Wingham Urban Release Area 1

ADDENDUM LETTER – AMENDED NOISE IMPACT ASSESSMENT

AMENDED NOISE IMPACT ASSESSMENT

**Transport Corridor & Shooting Range Noise Impact Assessment of
Proposed Residential Development
Lot 92 DP 1285477, Wingham Road, Wingham, NSW**

Figure 1: Wingham Road Precinct Plan (source: MPT Farms)

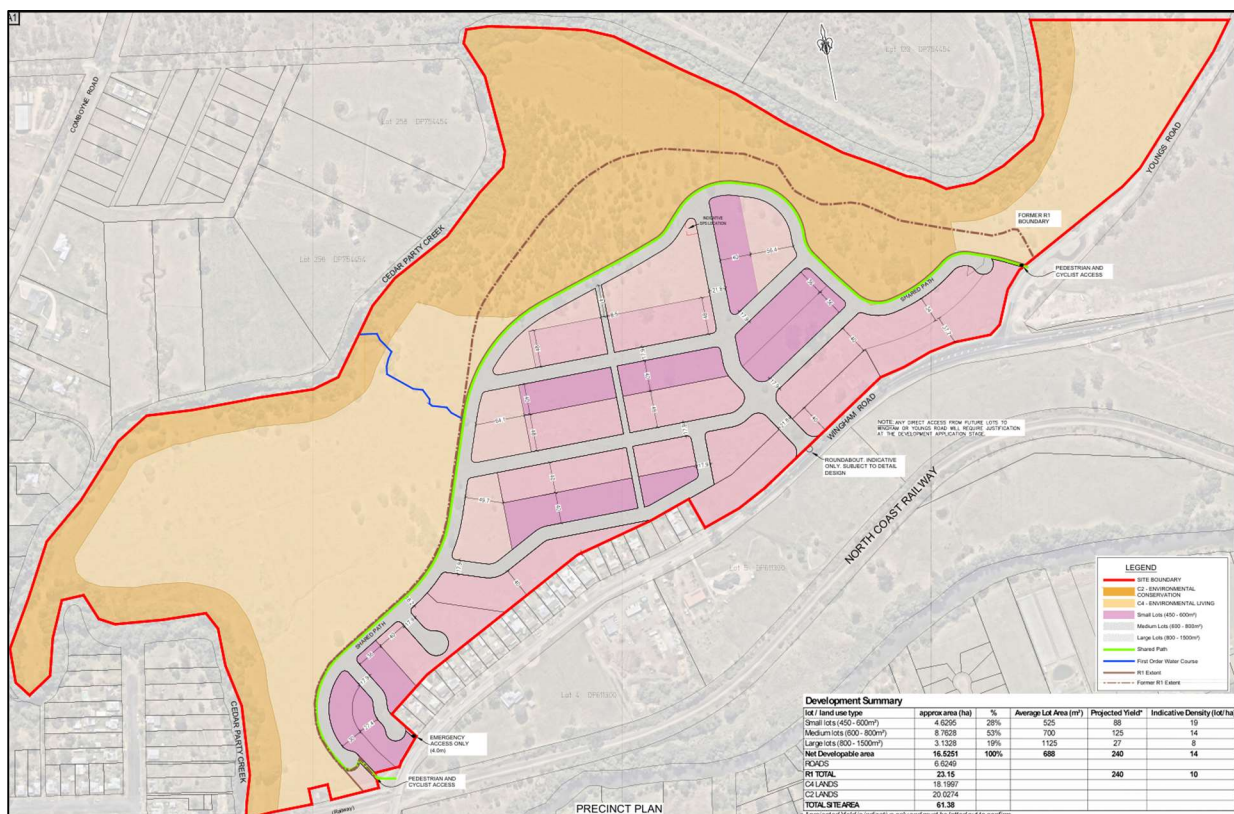
Amenity Acoustics understands that following finalisation of the NIA, the portion of the site proposed to be rezoned for residential development has been reduced to the area identified in the revised Precinct Plan in Figure 1 where the brown dashed line is the previous boundary. It is observed that an area to the north and to the east of the proposed development area has been removed from the area considered in the NIA, reducing the area from 28.56 ha to 23.15 ha.

The noise impacts of Wingham Road and Youngs Road, and the North Coast Rail train noise, are broadly unchanged under the revised Precinct Plan with only a negligible reduction in impact due to the reduced development area near Youngs Road. The assessment and figures in section 8 'Noise Modelling Results' remain appropriate although should be considered as a worst-case scenario.

To assess the potential impacts of the Shooting Club, attended and unattended noise monitoring was undertaken at "the most affected residential boundary", as required by the EPA's Target Shooting Ranges: Application Note for Assessing Noise Compliance (EPA 2015/0491) across two separate events. The NIA confirmed the shooting range is approximately 450 metres from the part of the site proposed to accommodate residential development. The distance from the Shooting Club increases with the revised Precinct Plan reducing the noise impact.

Based on review of the revised Precinct Plan, Amenity Acoustics confirms the NIA can be considered as a worst-case scenario for the noise impact on a future residential community with all impacts being equal or lesser than those considered during preparation of the NIA.

Amenity Acoustics confirms the impacts under the revised Precinct Plan will be less than those considered in the NIA and accordingly it is appropriate that the NIA can be relied upon for the rezoning process.
